# **Technical Review of Revised Regulatory Proposal**

## **Review of Proposed Replacement Capital Expenditure in Ausgrid's Revised Regulatory Proposal**

**Report to**  
**Australian Energy Regulator**  
**from**  
**Energy Market Consulting associates**  
**Strata Energy Consulting**  
**April 2015**

Figure 1: RCP step change in SCADA, network control and protection

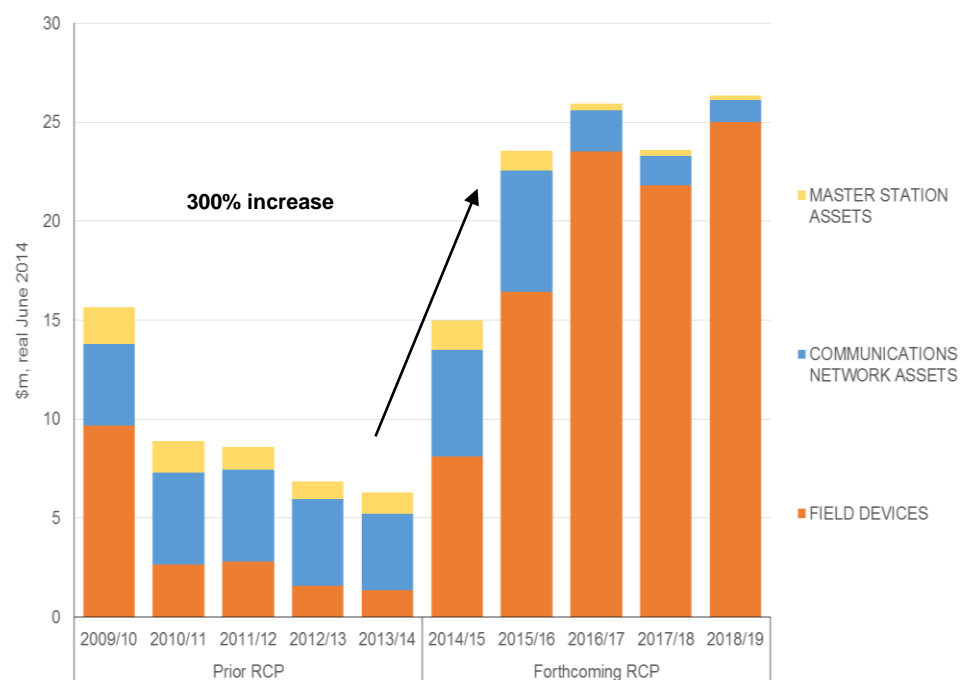
63. We found that Ausgrid proposed a \$100m+ expenditure program that appeared to lack sufficient justification, including a lack of: (1) reliable data; (2) robust options analysis; and (3) compelling financial analysis. Refer to Figure 1 below.

64. Ausgrid has recognised that the lack of data for the secondary protection and control systems asset class implies a higher level of uncertainty and that a better informed view of consequences as “informed by our revised risk-cost assessments” has reduced the program by 50%.<sup>17</sup>
